Reference: Chapter 40B Comprehensive Permit Modification
The Residences at LeBaron Hills - Phase 5 Modification
LeBaron Boulevard
Lakeville, Massachusetts
B+T Project No. M3420.00

Re: Response to Project Review Comments
Estates at LeBaron Hills - LeBaron Boulevard - (DEP File #192-0885)
Lakeville, Massachusetts

“The Estates at LeBaron Hills, Phase 5 Modification” Definitive Subdivision Review Response

Exhibit E

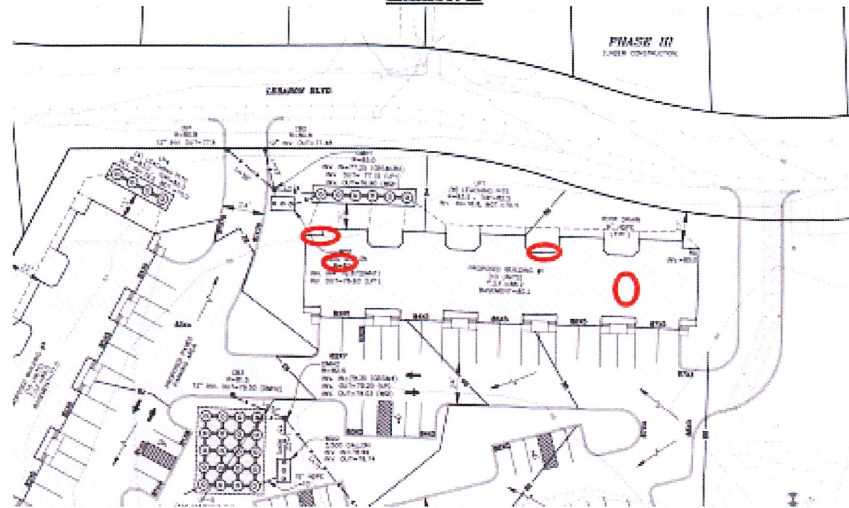
*Standing water channelization and typical wetland plants (Cattails (*typha sp.*) and common reed (*Phragmites australis*)) were observed in the vicinity of proposed Building #1. A current existing conditions plan has not been provided by the Applicant that would better define this area. We acknowledge the Order of Resource Area Delineation (ORAD) referenced that established the limits of the resource area for Thompson Brook; however, this area in question does not appear to be mapped. During, if not before, we recommend that this area be addressed in the Notice of Intent (NOI) submission with the Conservation Commission under the Wetland Projection Act regulations that are outside the Comprehensive Permit review process currently before the Board.*

Goddard Consulting Response: The area in question referenced in the Beals and Thomas review letter (comment #2) was inspected by Goddard on Monday, February 13th, 2023. The area is located next to LeBaron Boulevard in the vicinity of proposed Building #1 shown on the plan titled, "The Estates at LeBaron Hills" Phase V Modification, A Residential Subdivision in Lakeville, Mass., dated December 12, 2022, prepared by Outback Engineering Incorporated (see attached). Goddard observed standing water and phragmites in small, isolated areas in the vicinity of Building # 1. These areas were isolated and not hydrologically connected to any other resource area (see exhibit E). The Beals and Thomas review letter also mentions cattails were found on site however, no cattails were observed during Goddard's inspection, only the invasive phragmites. It is important to note that these small, isolated areas of standing water are within a previously disturbed area and were likely created due to tire ruts from heavy equipment. These areas were not flagged as isolated vegetated wetlands and were not included in the ORAD due to the fact that isolated vegetated wetlands are not jurisdictional areas under the Massachusetts Wetlands Protection Act (310 CMR 10.00).

This photo shows approximate locations of the small isolated phragmites growth (circled in red) observed on site in the vicinity of proposed building #1.

UTILITY PLAN
"THE ESTATES AT
LEBARON HILLS"
PHASE 5B
A
RESIDENTIAL SUBDIVISION
IN
LAKEVILLE
MASSACHUSETTS

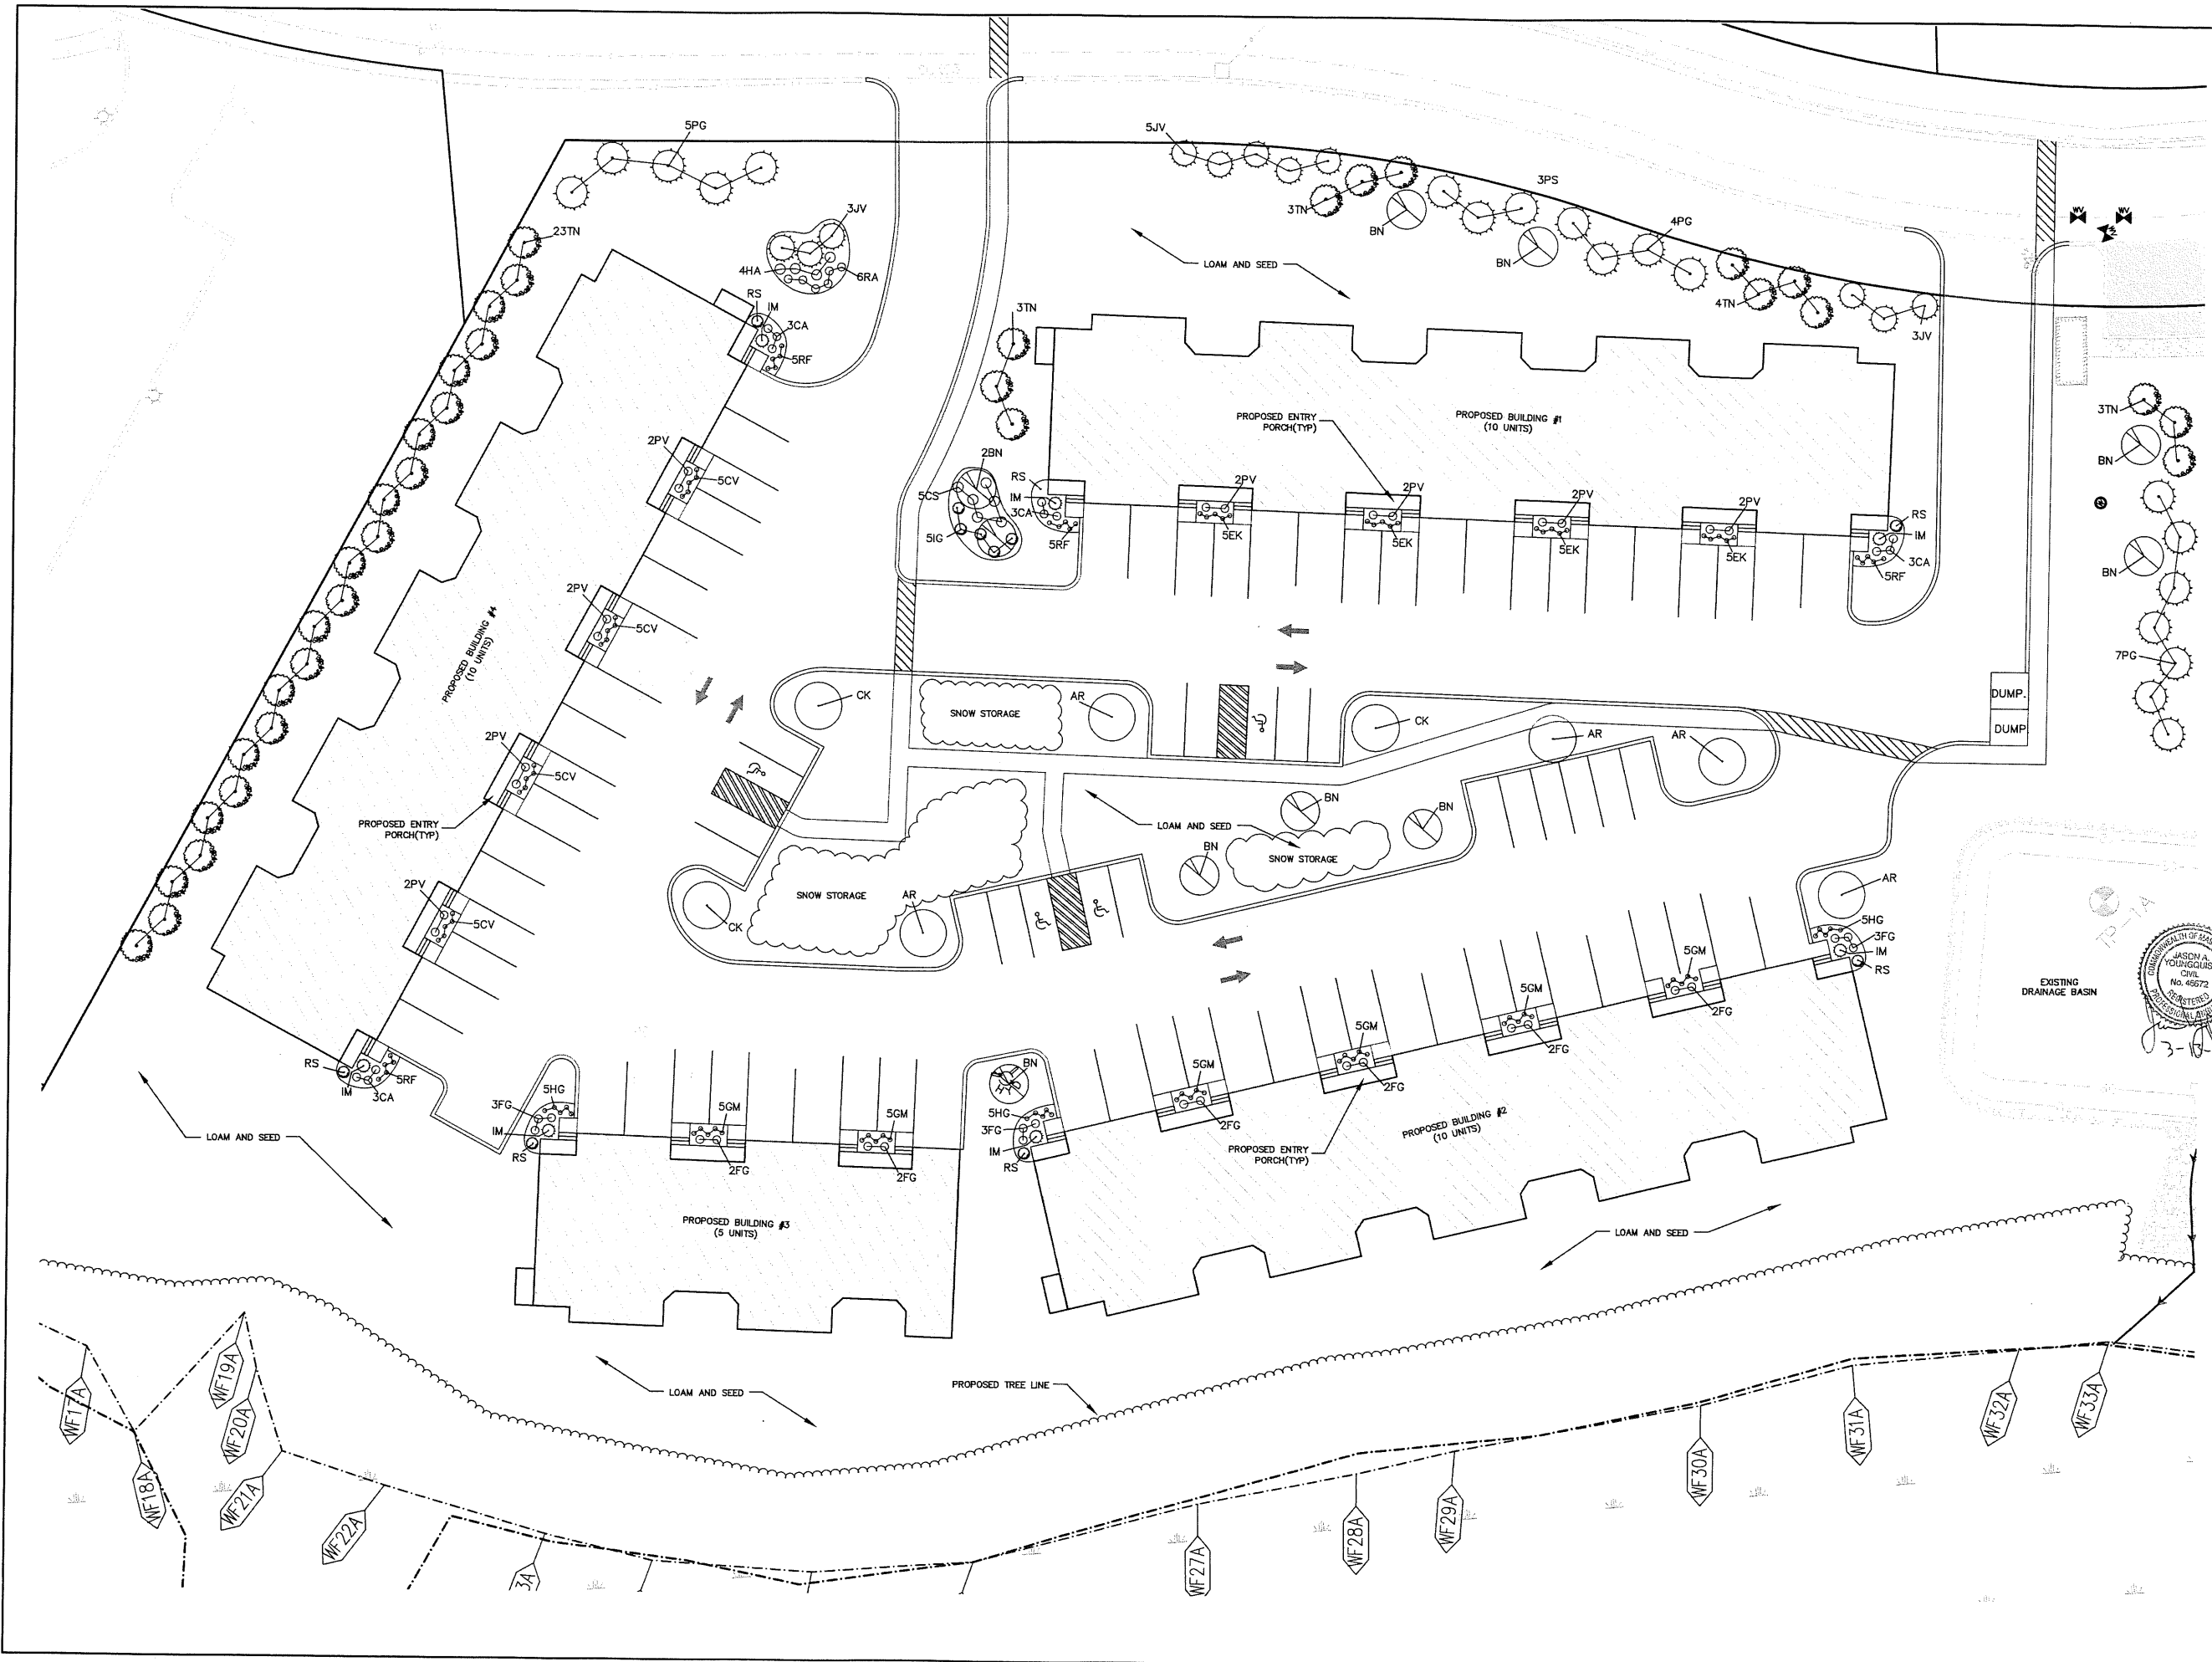
11. Water supply is proposed around the perimeter of the Project primarily behind the buildings and off paved areas. Fire hydrants are not depicted. We request that the Applicant clarify the water system design intent relative to providing for firefighting requirements.

13. Sewer manholes SHM2 and SHM3 are designed with a 4-ft internal diameter with multiple acute angles for the lateral connections. We request that the Applicant clarify the structural design of each of these structures and determine if the diameters need to be up-sized to accommodate the layout proposed. Additionally, the sewer lateral connections from Building #4 do not appear to intercept the trunk line. We presume this is a drafting error; however, request that the Applicant clarify the sewer design intent.

14. The Applicant has not depicted a corridor or layout for private electrical and telecommunication services. Understanding these services will need to be coordinated with the specific utility providers, we request that the Applicant provide and depict a proposed corridor for the reference utilities.

Response: The buildings will be equipped with fire connections which have been shown on the plan. In addition, a hydrant has been added to the site and the location of the existing hydrants at Phase 2 and 5 have been shown on the revised plans.

Response: The sewer manholes have increased in size to accommodate the pipe connections. In addition, the drafting error with the sewer lateral pipe connections has been corrected.

Response: The layout for the electrical and telecommunications has been added to the plans.

LEACHING PIT DETAIL
NOT TO SCALE

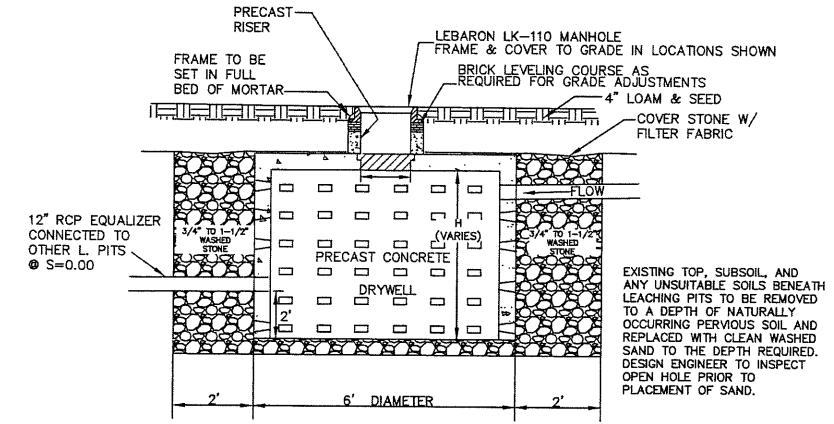
24. The modeling of the leaching pits is unclear. The elevations used do not appear to correlate to the model. The modeling assumes 1-ft of stone below these structures where the detail does not. We request that the Applicant clarify the design intent for the referenced infrastructure.

25. The modeling of the leaching pits LP-1 and LP-4 is unclear. The elevations noted on the plans do not appear to correlate to those used in the model. We request that the Applicant clarify the design intent for the referenced infrastructure.

Response: The leaching pit detail has been revised to correlate with the HydroCad modeling.

Response: The HydroCad modeling of the leaching pits has been revised and the plans updated to correlate with the modeling.

FLARED END W/RIP-RAP DETAIL
NOT TO SCALE

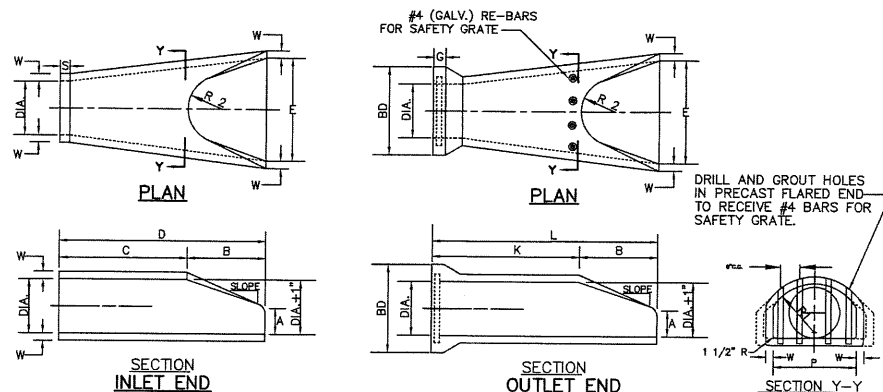
23. We acknowledge the stormwater basin design and the outlet control structure proposed. However, the basin design does not include an emergency spillway if the outlet control structure becomes clogged or comprised. If the basin were to overtop, we recommend a spillway for this to happen in a controlled manner in a single area to limit erosion. We request that the Applicant clarify the stormwater basin design.

Response: Due to the grading changes the infiltration basin has been revised to leaching pits with an outlet pipe. Outlet pipe to be constructed with a flared end and rip rap protection.
